Our Ref: 17106
10 May 2017

RE: BALLINA PUBLIC SCHOOL

Further to your recent request, the Transport Planning Partnership (TPPP) has reviewed the traffic reports in relation to the above school and their subsequent letters addressing several authority responses.

No. of Occupied Bays and Utilisation Rates

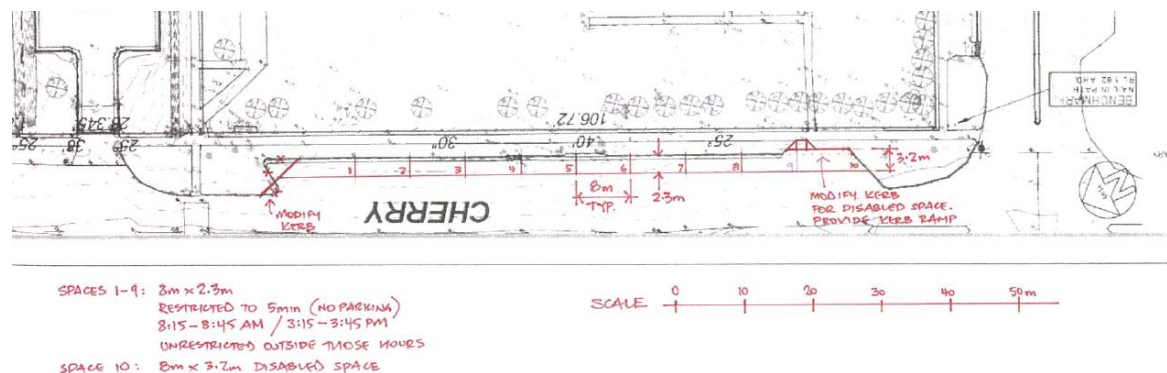
On this basis, the traffic report has assessed the potential capacity of these parking areas and has identified that with some sealing and line marking, the existing parking around the perimeter of the site has capacity for 122 spaces as shown below.

Ardill Payne has then undertaken an occupancy count of these spaces and with this information has concluded that the maximum number of spaces that were occupied is 32 spaces. There is an available capacity of 90 spaces at any time.

It is TTPP's view that it is not sustainable to provide 76 (or 110) spaces on site when there are some 90 regularly unoccupied parking spaces already provided around the perimeter of the site. These parking spaces clearly provide little benefit at the moment and their use, during school hours, would be a sustainable use of this parking. Furthermore, excavation of some 3000m² of a valuable site to re-provide these levels of parking on-site when there is available and unused parking space around the perimeter of the site is not sustainable. The use of this parking and the loss of these spaces to the wider public during school hours would be negligible as stakeholders, other than the school, do not appear to use these spaces to any great extent.

TTPP conclude that all of the parking requirements for the school could easily be provided in parking areas already located around the perimeter of the site. It seems unsustainable to build a car park on site of between 76 and 110 spaces in site in order to replicate these 99 unused parking spaces around the perimeter of the site. There is little current demand for these on-street parking spaces – what little demand there is during the day is probably as a result of parking demand at the school – and it is my view that other stakeholders would not be affected by the school using these parking spaces.
